**Bureau of Environmental Health**

RECEIPT DATE: 3/11/16**ONSITE SEWAGE DISPOSAL SYSTEM**P 558026APPROVAL DATE: 3/29/16**PERMIT:****REPAIR**

PROPERTY ADDRESS: 17105 Spring Hollow CourtSUBDIVISION: Spring HollowLOT: 2TAX ID: 04-362748CONTRACTOR: Fogle's Septic Clean Inc.EMAIL: kevin@foglesinc.comCONTRACTOR ADDRESS: 580 Obrecht Road, Sykesville, MD 21784PHONE: 410-795-5670PROPERTY OWNER: Mike Baker

The Baker Residence

HOUSE LOCATION DRAWING

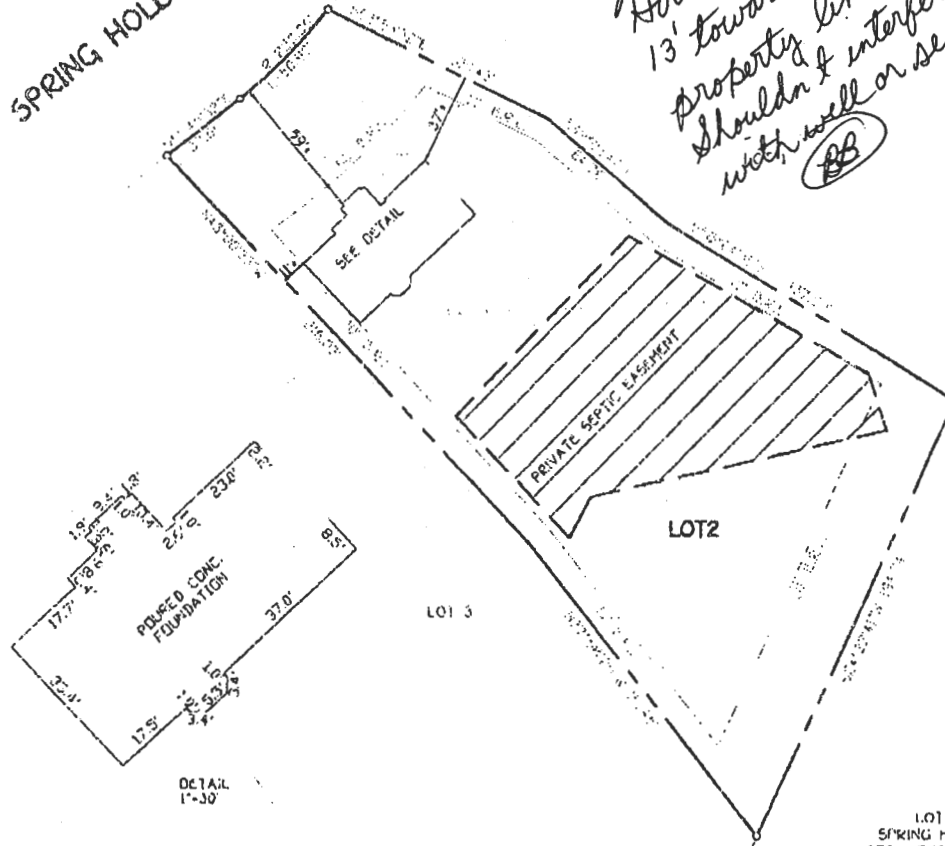
House moved
13' toward right
property line.
Shouldn't interfere
with well or septic.
(BB)

SITE PLAN

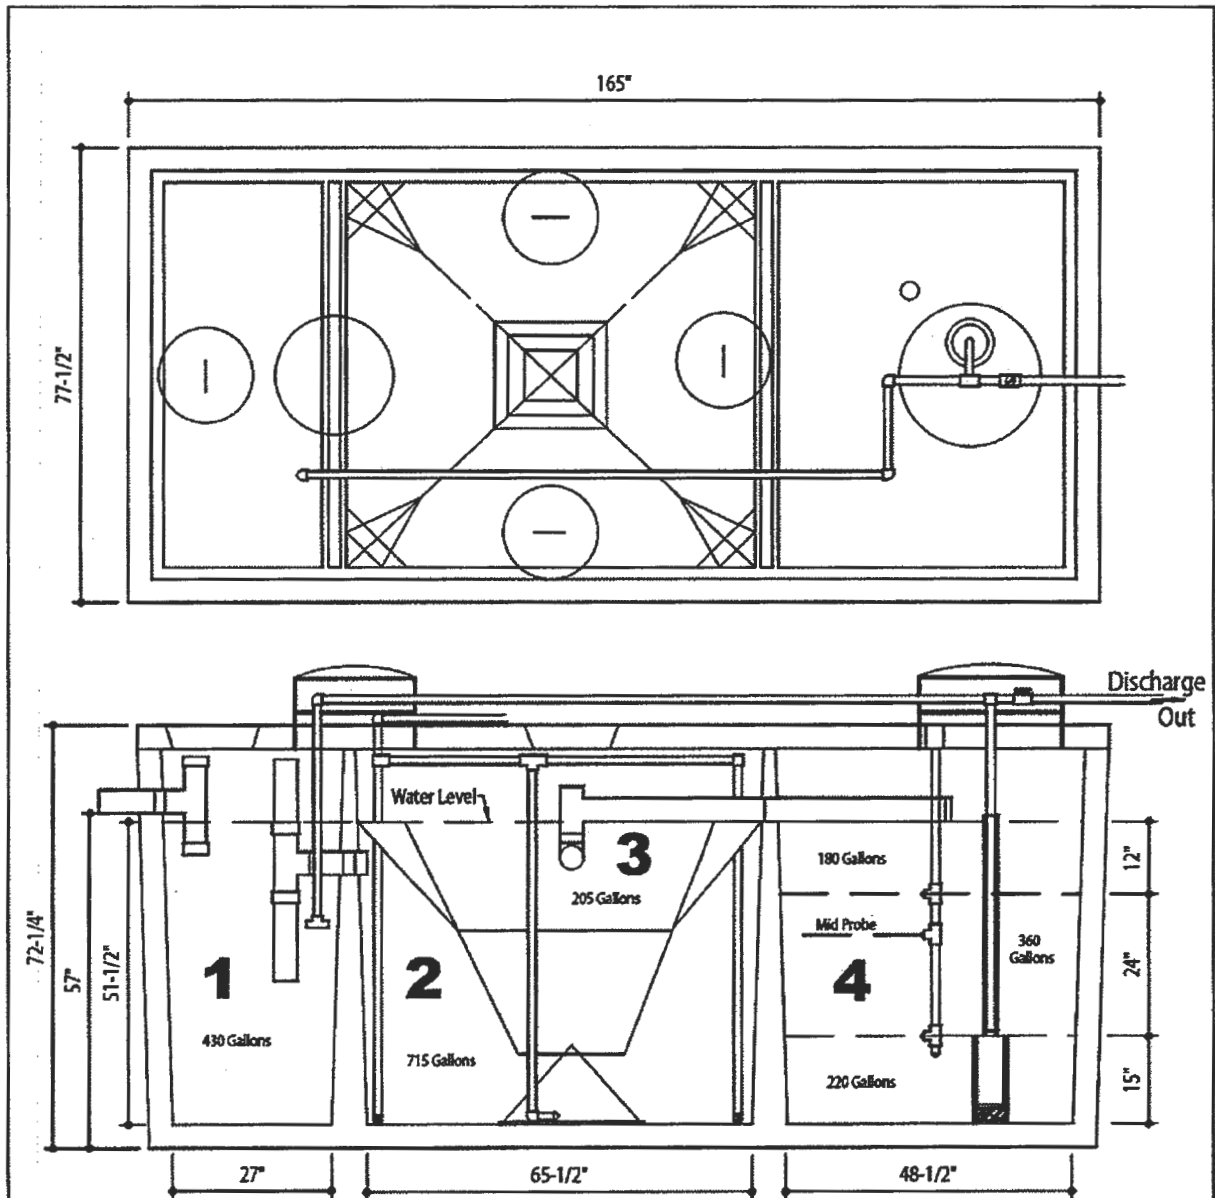
The existing system is currently sized for 4 bedrooms. The floor plan shows a total of 6 bedrooms. Before this office can approve the building permit, the septic system would have to be upgraded to a BAT unit sized for 6 BR's and a pump tank capable of handling 1 day of emergency storage. The existing trenches are sized properly for the proposed use but we will need to see how one replacement system will fit inside the existing sewage disposal area (SDA).

Thank you for submitting the revised site plan & floor plan for the first floor plus changes to existing garage. In order to determine if the existing septic system is sized properly for the existing house plus proposed changes, this office will also need to see a floor plan of the existing basement and second floor.

My phone is currently down. To receive BP approval by the Health Department, the septic tank and pump tank would have to be upgraded to a BAT unit designed for 6 bedrooms and pump tank capable of handling one day of emergency storage for a 6 bedroom house (Under current standards, septic systems are designed by # of bedrooms - COMAR 26.04.02). The existing trenches are large enough to accommodate 6 bedrooms so nothing has to be done with them. In addition to the tank and pump tank upgrades, we need to see how one replacement trench system will fit inside the existing sewage disposal area. This information would have to be outlined on a BAT Plan usually designed by an engineer for review and approval. Please see attached BAT Plan requirements. Also, a septic permit and inspection will also be required by this office for this upgrade. Should you have any questions, please don't hesitate to ask
